TECHNICAL PROPOSAL
FOR
SIMPLIFICATION OF HAND CONTROL
PE 500-0133

PREPARED FOR HF 20-80
JANUARY 23, 1957

**TECHNICAL PROPOSAL
FOR
SIMPLIFIED HAND CONTROL, MK II**

FIG 1

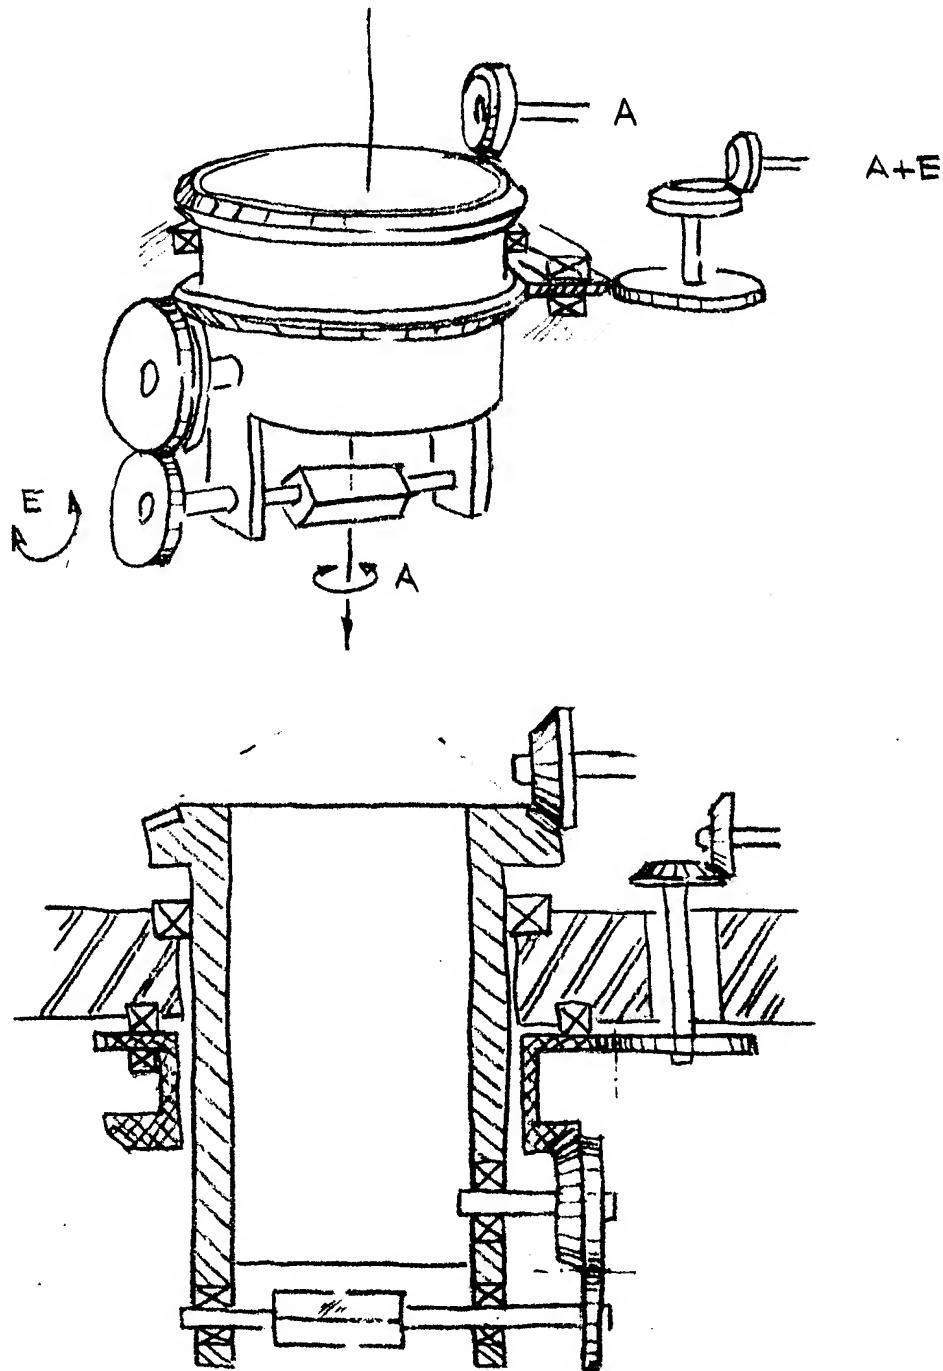
Figures 1, 2 and 3 illustrate the system currently used in Hand Control
REPORT NO. PAGE 3

PE 500-0133 for moving the line of sight and the modifications thereto for elimination of track and drift settings.

FIG 2

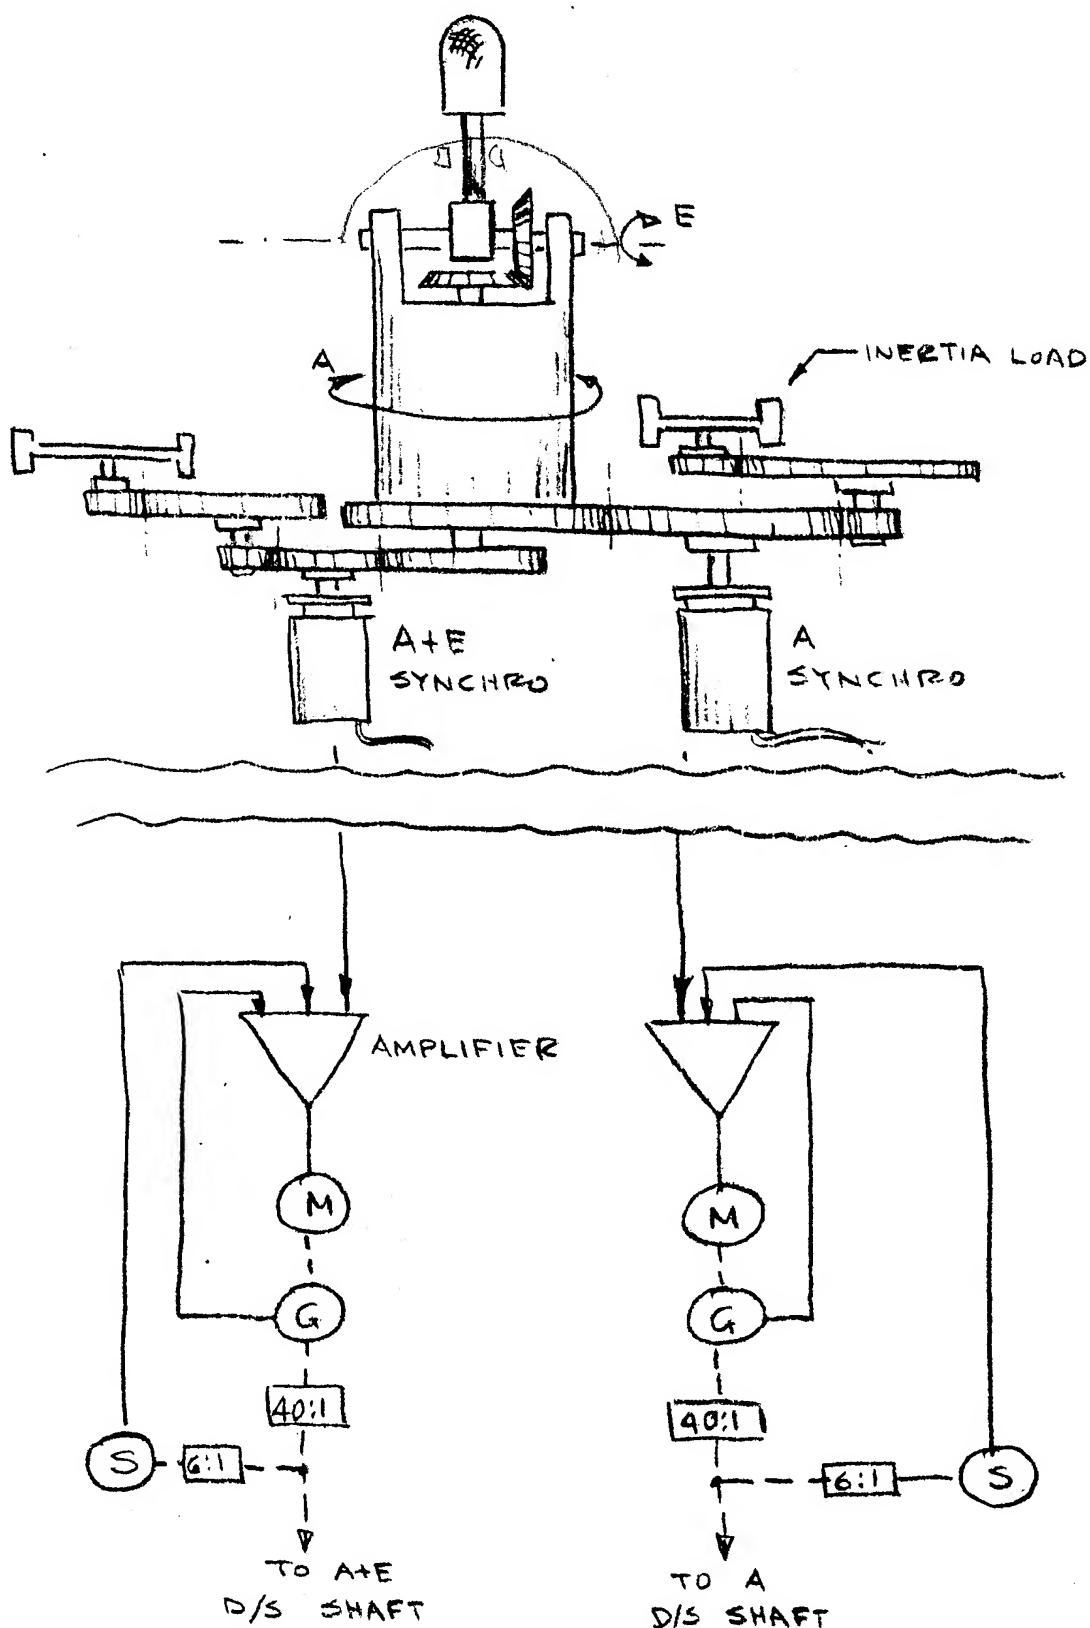
These controls will be eliminated since the prime feature of this redesigned Hand Control is to provide a means for the pilot to see outside his craft and to scan in all directions. Elimination of these controls will eliminate the integrator, tracking rate motor, and associated gear meshes. Further, since the unit will not and cannot be used with the C Configuration (and Computer attachment) the alpha and beta bale rings, and alpha and rate potentiometers will be removed as will their associated gears and shafts.

Since no tracking feature is available there is no need for declutching the unit by depressing the handle, thereby eliminating the slip clutches, relay and associated circuitry.

The A and A & E synchros, the two transistorized amplifiers and power inverter (28VDC to 400 cps) will be retained since this servo loop is required to control the scanning of the Drift Sight.

-TOP PANEL -

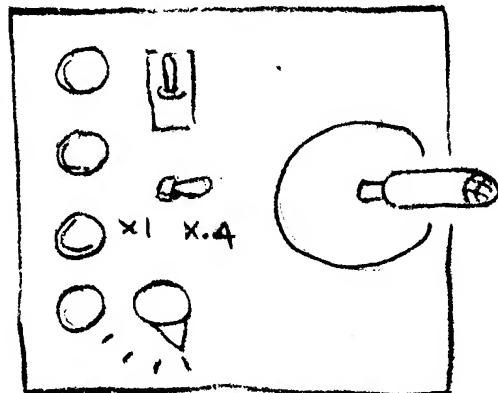
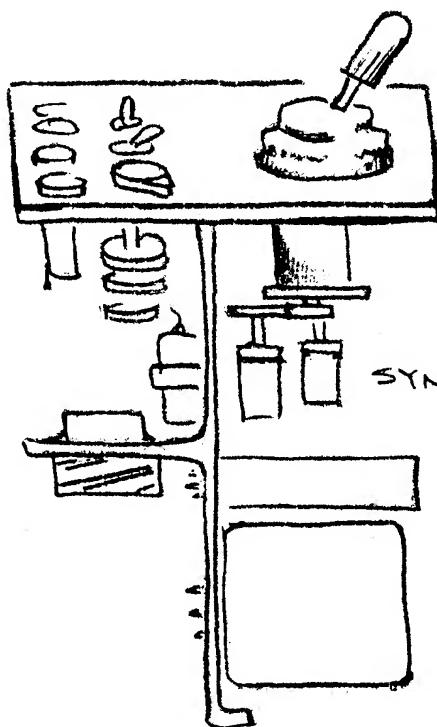
The current electrical controls (lights, mode switch, master switch and power changer switch) will be retained unchanged. However the "Store" momentary switch which is used with the "C" Configuration and Computer unit, will be eliminated.
